Clinch River Nuclear Site
NRC Docket No. 52-047

Subject: Response to Request for Additional Information Number 4, eRAI-8857,
Regarding Population Distribution in Support of Early Site Permit Application
for Clinch River Nuclear Site

Response to NRC Request for Additional Information Number 4, eRAI-8957

Figure 1, Distance to Urban Areas Near CRN Site

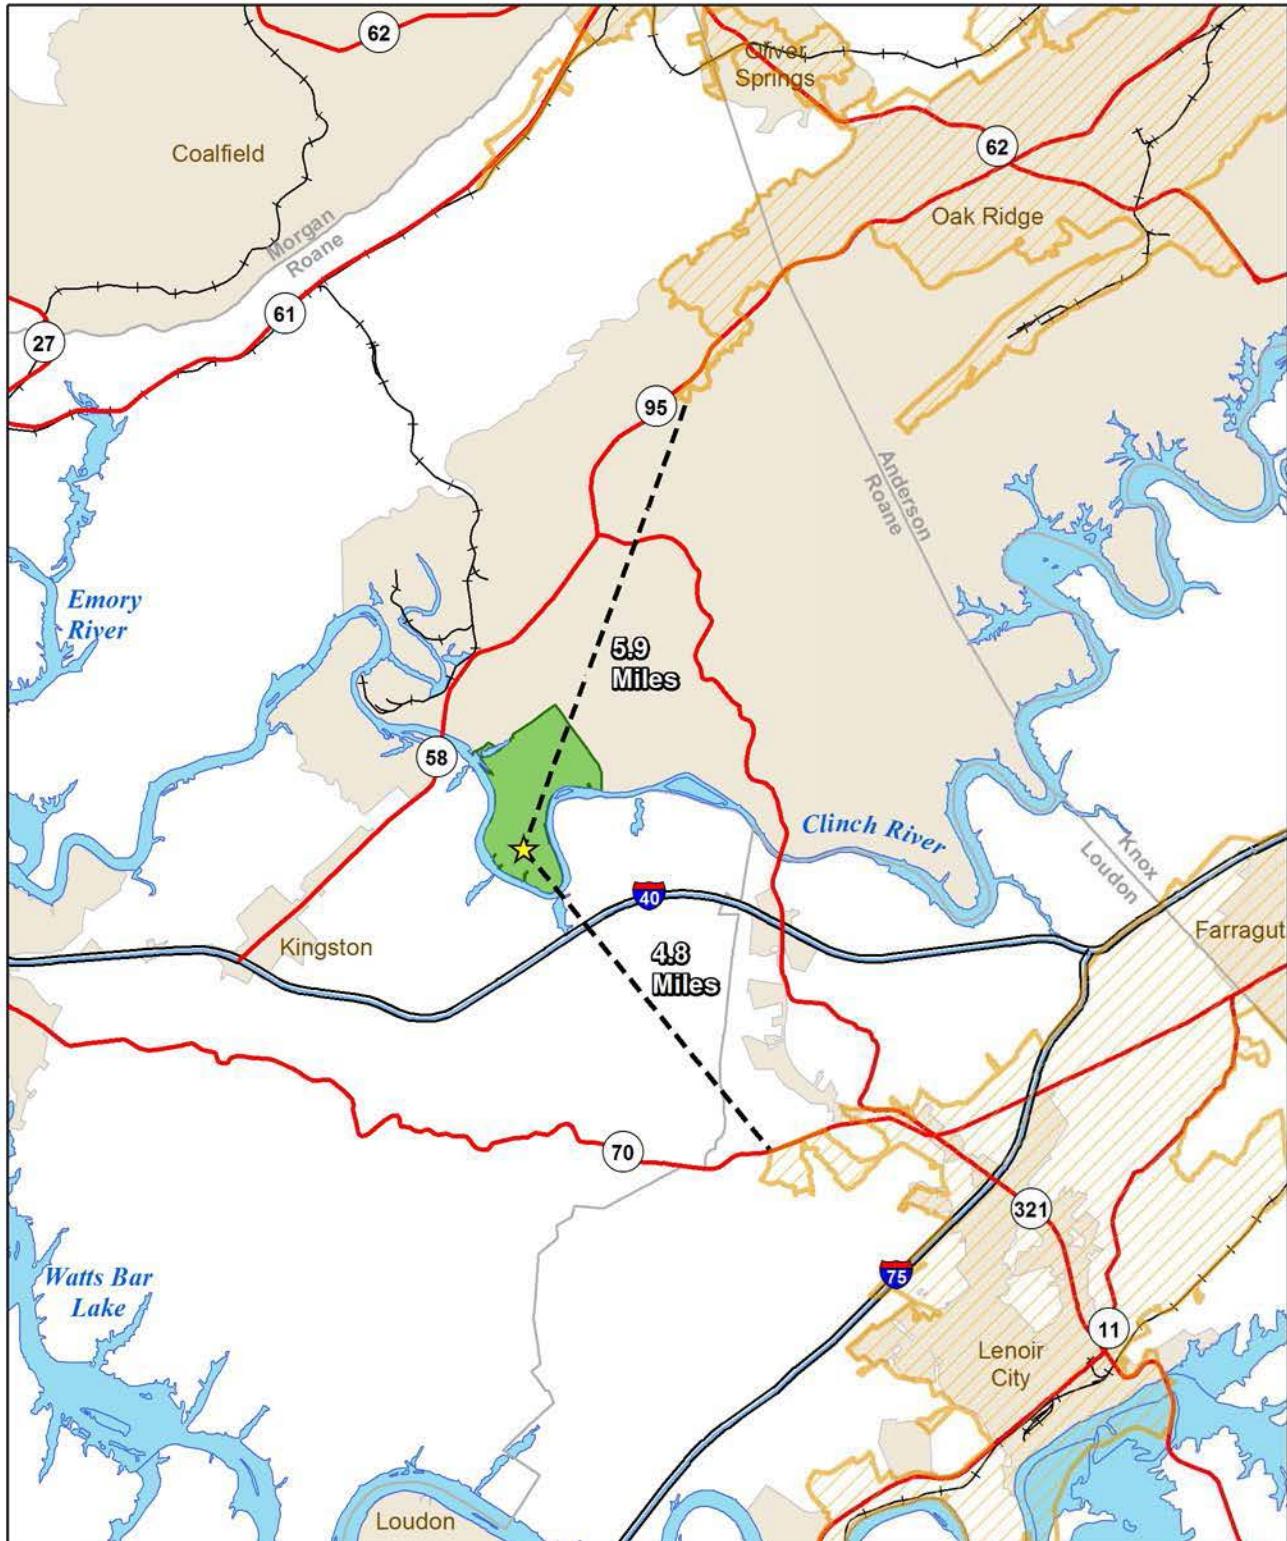
RG 1.206 provides guidance regarding the information that is needed to ensure that the information identified and evaluated to meet the siting criteria in 10 CFR 100.20(a) and 10 CFR 100.21(b). The applicant used USCB census-delineated urban areas in the region based on population density. The two urban areas identified are the Knoxville (4.8 mi southeast) urban area with the combination of smaller cities including Lafollette, Oak Ridge, Clinton, Loudon, Lenoir City, Alcoa, Maryville, Farragut, Rockwood, Seymour, and Knoxville; and the Cleveland (45 mi south-southwest) urban area with the combination of smaller cities including Calhoun, Charleston Hopewell, and Cleveland, Tennessee. The Knoxville and Cleveland urban areas had 2010 populations of 558,696 and 66,777 persons, respectively. The distances of these identified urban areas are much greater than the one and one-third times the distance from the site center point to the outer boundary of the LPZ.

The applicant considered meeting the population center distance requirement (10 CFR 100.21(b)), based on the distances from the site center point to the boundary of each of the two identified urban areas in Knoxville, Tennessee, which is 4.8 mi southeast and Cleveland, Tennessee, which is 45 mi south-southeast. Both of these population centers are much greater than the one and one-third times the distance from the site center point to the outer boundary of the LPZ. But the applicant followed an approach by using urban area designation with combination of smaller cities for complying with the population center distance of one and one-third times the distance from the reactor to the outer boundary of LPZ. This approach differs from the regulatory requirement, and could set a new precedent as it considers and combines various small cities of lesser than 25,000 people, rather than considers a city with a densely populated. This effectively changes the distances identified to meet the regulatory requirements. Although in this case the result may be more conservative, the analysis is still not in accordance with the regulatory definitions or requirements as specified in 10 CFR 100.21(b). Therefore, the staff requests the applicant in RAI 2.1.3-1 to revise the evaluation methodology in meeting the 10 CFR 100.21(b) regulatory requirement, solely based on considering the nearest city having population of 25,000 or more people.

There are no population centers located within the minimum population center distance required by 10 CFR 100 (e.g. one and one-third times the distance from the site center point to the outer boundary of the Low Population Zone (LPZ)). As described in the SSAR Subsection 2.1.3.5, there are only two urban areas within the region that meet the requirements to be considered population centers: Knoxville and Cleveland (Reference 1). These are located approximately 4.8 miles (mi) (southeast) and 45 mi (south southwest), respectively. As described in SSAR Subsection 2.1.3.5, the densely populated areas associated with the City of Oak Ridge and Lenoir City are included in the United States (U.S.) Census defined Knoxville Urban Area. Figures 1 and 2 illustrate the geographic relationship of the Knoxville Urban Area, the City of Oak Ridge and Lenoir City densely populated areas, and their distances to the CRN Site reactor. As noted in the figures, the densely populated portion of the Knoxville Urban Area attributed to the City of Oak Ridge is located approximately 5.9 miles north northeast. The portion of the Knoxville Urban Area attributed to the Lenoir City dense population areas is approximately 4.8 miles southeast. SSAR Figure 2.1-6 and Table 2.1-2 provide the population distribution surrounding the CRN Site by distance and direction. Both the table and the figure illustrate that the locations of the densely populated areas associated with these cities are beyond the distance required by 10 CFR 100.21(b) and satisfy Regulatory Guide 4.7, General Site Suitability Criteria For Nuclear Power Stations.

For the Clinch River region, all UAs and UCs having greater than 25,000 persons were identified as population centers and the distances reported in SSAR Subsection 2.1.3.5. None of the identified population centers were located within one and one-third times the distance from the site center point to the outer boundary of the LPZ.
